THE MARYLAND-NATIONAL CAPITAL PARK AND PLANNING COMMISSION

REVIEW TYPE: Mandatory Referral

PROJECT NAME: Montgomery Hills Junior High School Reuse

CASE NUMBER: 02107-DPWT-1

SITE CIRCULATION
DIAGRAM

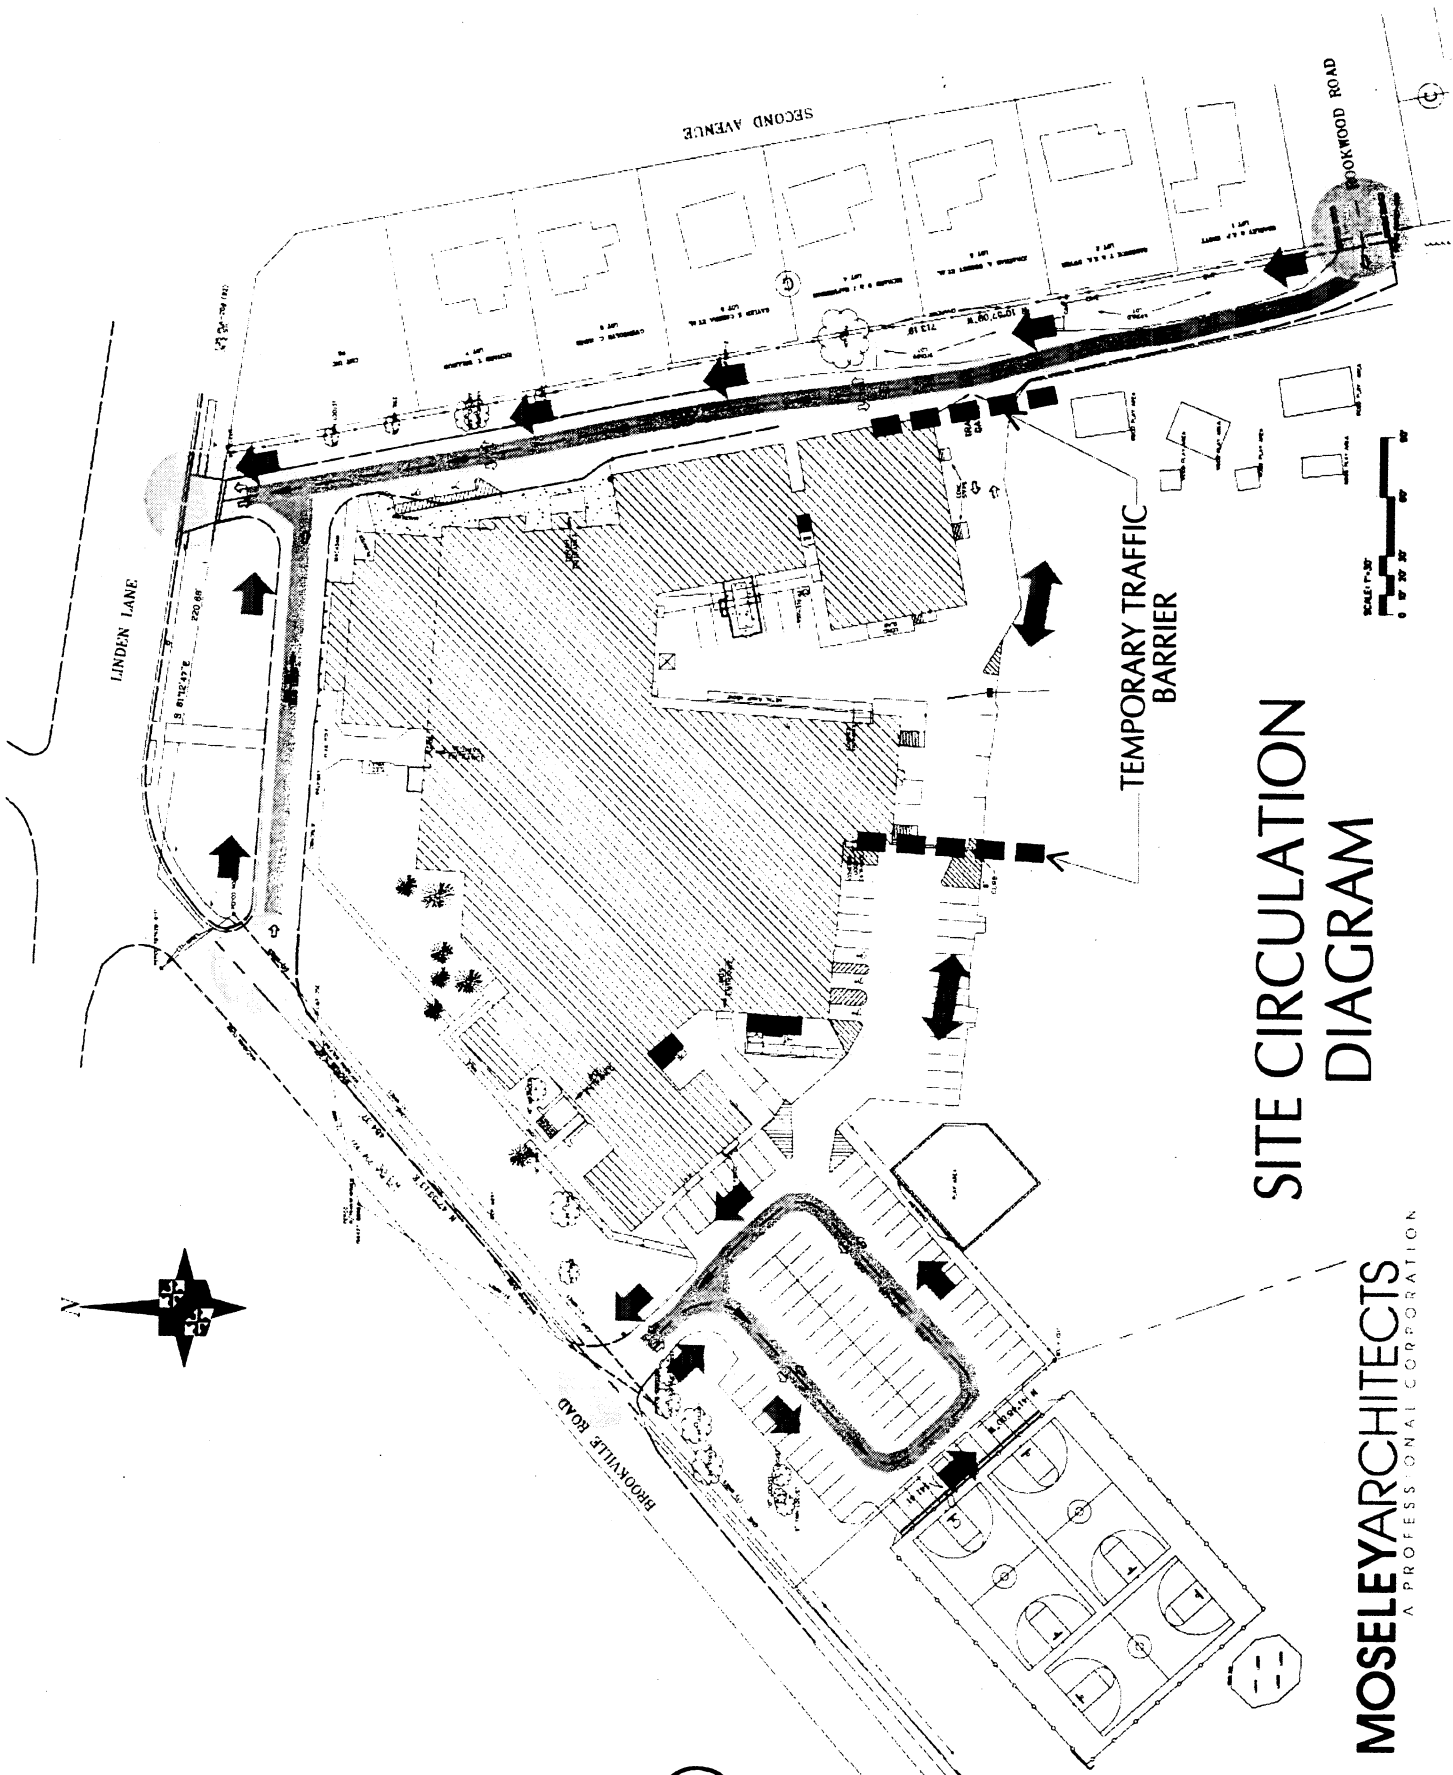
The MHJHS proposal houses three institutions in different parts of the school. They are JDPS, Yeshiva and Torah schools. The site plan for the renovated MHJHS provides separate entrances for the JDPS, Yeshiva and Torah School to accommodate the religious customs for these three schools. The separate entrances for the three schools impact the circulation pattern at MHJHS as discussed below. The JDPS desires to have its own separate access to the building. Yeshiva/Torah School would access the building from the alleyway along the east side parallel to Second Avenue. The JDPS would access the building from the Brookville Road driveway on the southwest corner of the campus. There is a faculty parking lot just to the south of the Brookville Road driveway where vehicles circle to drop-off or pick-up the students at this location. A driveway connects west and the east sides of the campus along south of the school buildings. This driveway is currently chained off to prevent cut through traffic from Brookville Road to Rookwood Road and Second Avenue. The circulation plan submitted to the Planning Department shows the location of the drop-off and pick-up for Yeshiva/Torah students on the alleyway along the east side of the campus gaining access from Rookwood Road.

As indicated in Table 2, the short driveway (labeled Queuing Area #1) adjacent to the Yeshiva School entrance will only accommodate nine vehicles. The schools recognize that this driveway is insufficient to serve as a location for school dismissal, and, therefore, propose that both Yeshiva and Torah Schools share the driveway (Queuing Area #2) along the site's east side. During school arrival and dismissal times, vehicles would enter this driveway from Rookwood Road and depart via Linden Lane.

Community representatives have requested that Rookwood Road be closed to reduce the amount of traffic using this road to travel between Second Avenue and Linden Lane. However, if Rookwood Road were closed, the east driveway would not be functional as a location for school dismissal operations because insufficient U-turn space exists for dismissal queue formation. If Rookwood Road were closed, staff finds the most effective operation would be for traffic destined for the Yeshiva and Torah Schools on the east side to use the Brookville Road driveway. The chained connector road on the south side of the buildings would need to be opened, at least during arrival and dismissal periods, to allow traffic to move from the west side to the east side of the campus. The Yeshiva and Torah School traffic would need to travel a circuitous path through the western parking area, adjacent to the JPDS queue.

Finding #3: The alternative circulation plan, including the closure of Rookwood Road, is undesirable due primarily to on-site safety concerns associated with conflicting traffic movements at the JPDS entrance. From the perspective of community protection, staff concurs with the Woodside community that shifting traffic from secondary and tertiary roads like Second Avenue and Rookwood Road to arterial roadways like Brookville Road and Lyttonsville Road is generally desirable. However, since all these roadways have substantial residential property frontage, staff notes that the effect of closing Rookwood Road is essentially to move the annoyance from one residential community to another. More important, staff finds the introduction of Yeshiva and Torah School traffic into the JPDS student loading/unloading area to be unacceptable.

Staff recommends that the circulation plan proposed by DPWT, with the traffic accessing the Yeshiva and Torah Schools via Rookwood Road is the most effective way to accommodate the needs of all three schools on the existing site. Staff recommends that this operation be implemented and monitored while the school develops a revised site plan for mandatory referral review by the Planning Board that reflects the relocation of one of the schools, presumably JPDS. The revised plan should either reflect the closure of Rookwood Road for recurring school activities or document the adverse impacts that prevent Rookwood Road closure.
